**ADDENDUM NO. 2**  
**February 7, 2019**  
**ISLINGTON STREET CORRIDOR IMPROVEMENTS – PHASE 1**  
**PORTSMOUTH, NEW HAMPSHIRE**

1. Sheet 76 of 88 – Utility Plan Notes

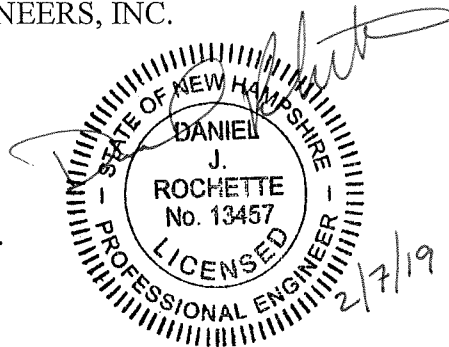
a. Water Key Note #5

**Delete** the note and **Replace** with the following:

“Existing water main outside proposed utility trenches shall be abandoned in place. See Watermain Abandonment Detail (Addendum #2, Attachment “A”), subsidiary to proposed utility installations. Removal of pipe within proposed utility trenches will be subsidiary to respective utility installations.
